**Proposed Composite Development (with Flat and Retail/F&B)
with Minor Relaxation of Plot Ratio Restriction
in "Commercial (2)" Zone at 8 Lam Chak Street, Kowloon
- S16 Planning Application –
TPB Ref.: A/K22/50**

(Planning Application No: A/K22/50)

RESPONSE-TO-COMMENT TABLE

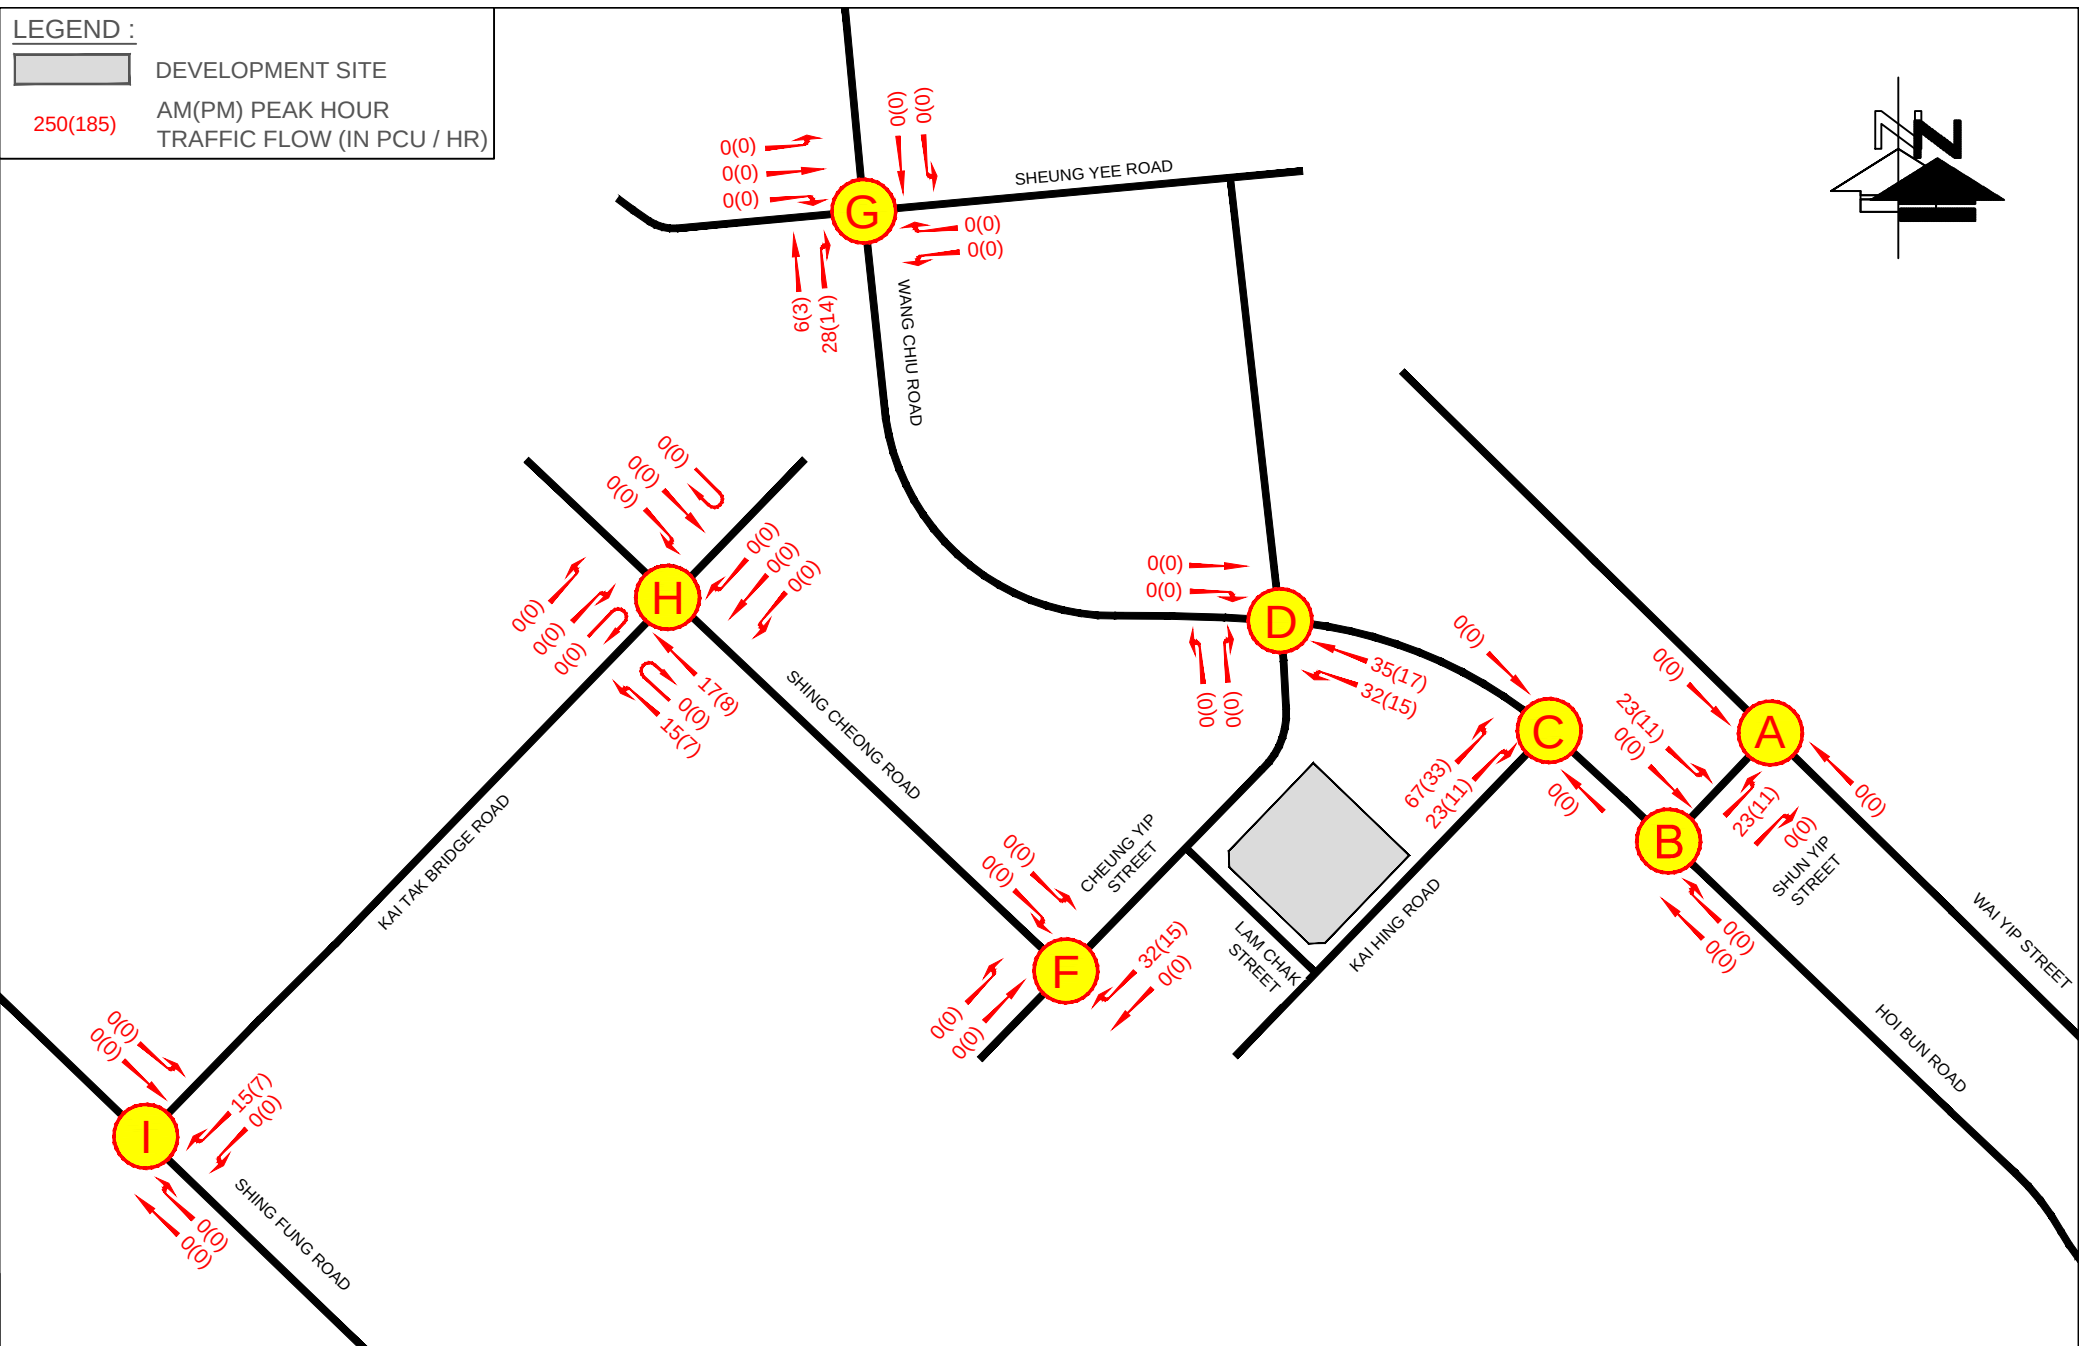
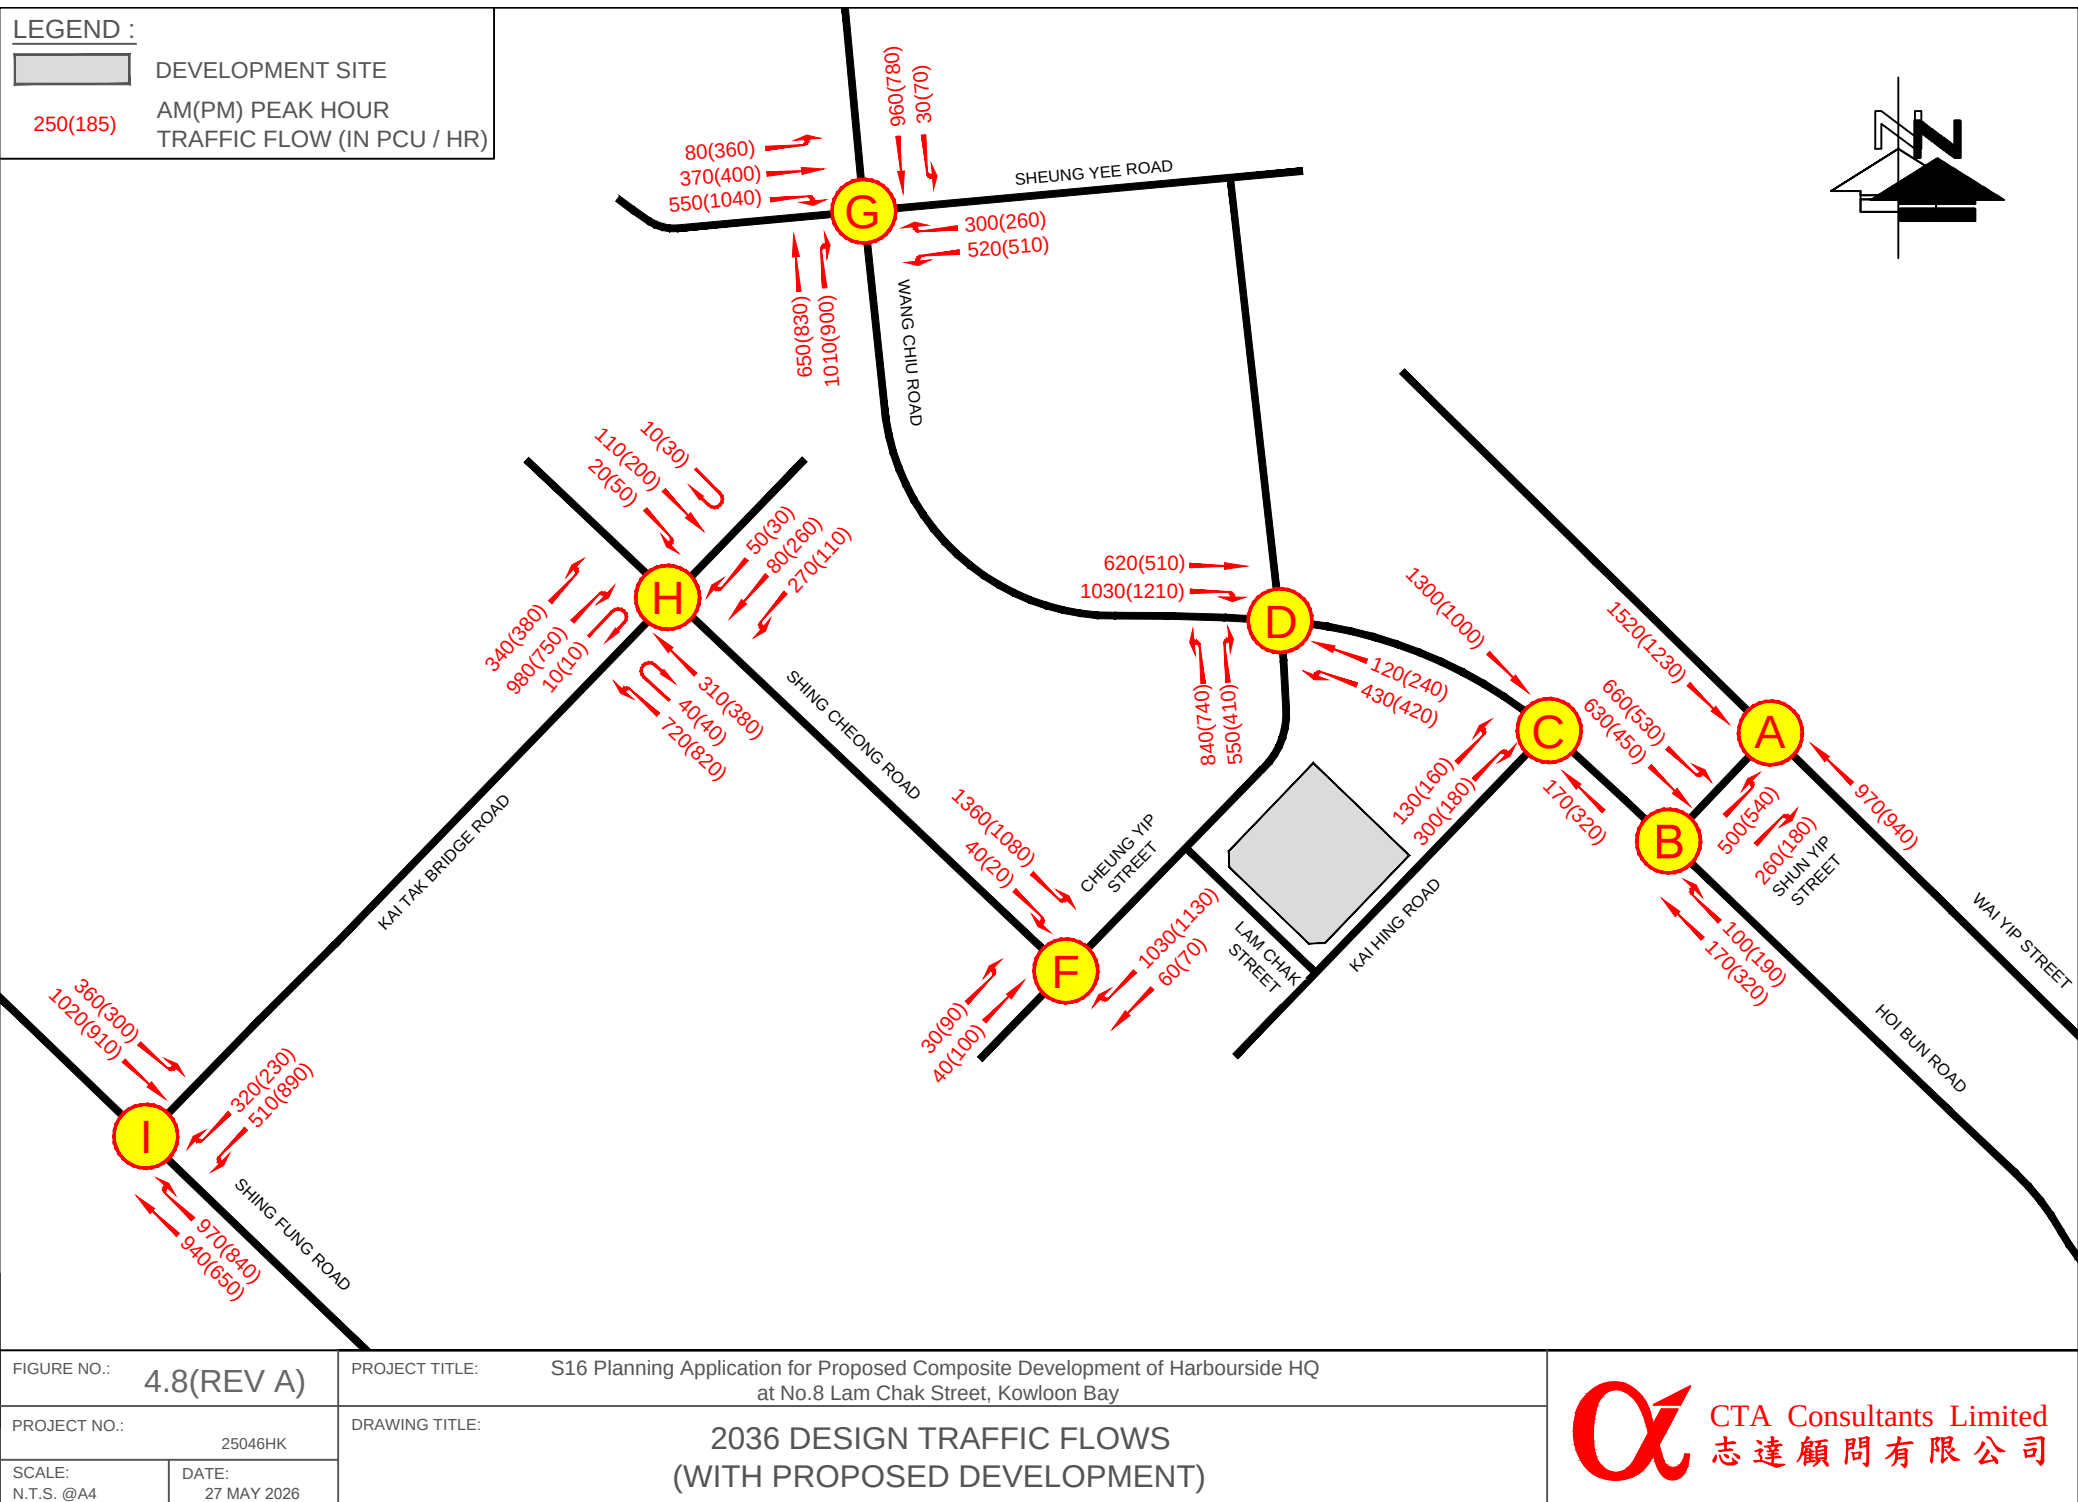
Comments	Response
Towers (i.e. Tower 1A, 1B, 2A and 2B) instead of two, where each tower is served by independent residential lobby. Please review the No. of Towers and update the number of visitor parking space & L/UL. - Figure 4.6 & 4.7: Please elaborate how the future traffic generations of the development were assigned onto the road network. ” <u>Supporting Planning Statement</u> - Para 3.2.6 & 4.6.2: Noted it is proposed to have a “landscaped public passage along the north-eastern boundary which will be opened to the public 12 hours a day. In general, public passage refers to a 24-hour public access. Please review the terminology and clarify the opening hours of this passage. ” <u>Appendix I: Schematic Architectural Drawings</u> - Referring to the “Indicative Ground Floor Plan”, please review the area demarcated as “landscape area at ground level / on grade”. It appears that some areas should be paved area for the “public passage” and the outdoor dining area. <u>Appendix III: Traffic Impact Assessment</u> - Table 5.2 & Para 5.1.4: It appears that the queue length at Cheung Yip Street N/B at junction F presented in Table 5.2, has significant variation to the figures presented in CEDD’s recently approved planning application for Kai Tak Area 3E Sites 1 and 2 (your reference traffic flows). Please review on the significant variation.	other essential provisions at the typical floor level, therefore they are considered as one tower. Please refer to Figure A of the revised TIA report in <i>Appendix III</i> for the layout plan. Please note that the future traffic generations of the development were assigned onto the road network with reference to the assignment of BDTM. Minor adjustments were made for major road network without traffic. This passage will be managed and maintained by the Proposed Development but to be made available for public to pass through during specific hours. The design of this area will be subject to detailed design and will be available at a later stage The queue length at Cheung Yip Street N/B at junction F has been reviewed and revised. Please refer to Table 5.2 and Para. 5.1.4 of the revised TIA report in <i>Appendix III</i> for details.

INDICATIVE SECTION A-A

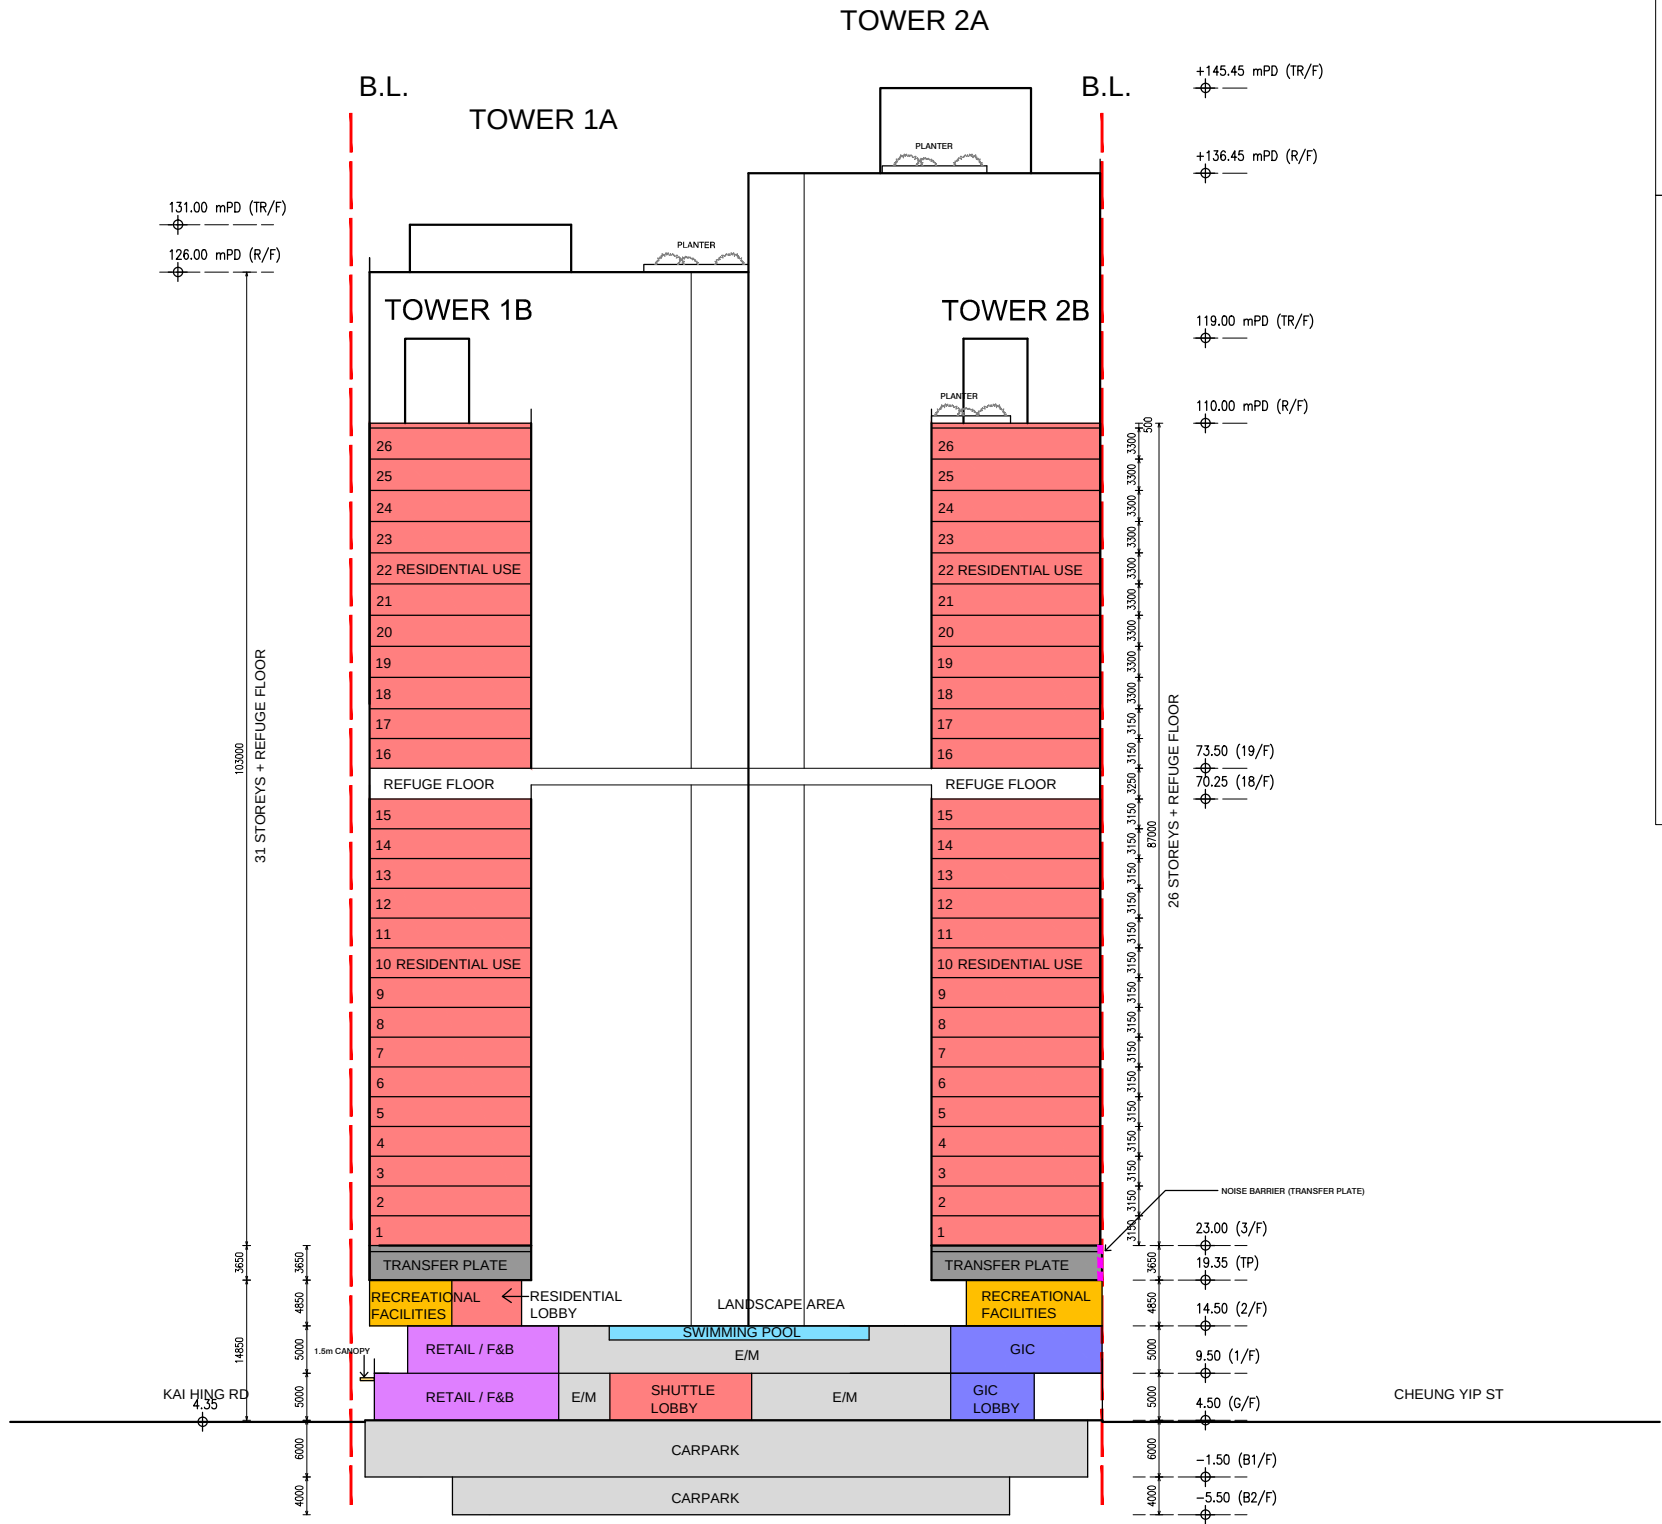
3. Appendix 1.1 Please indicate the location of the noise barrier in the figure “Indicative Section A-A”.	Noted, location of noise barrier has been illustrated in Section A-A (<i>Appendix I</i> refers).
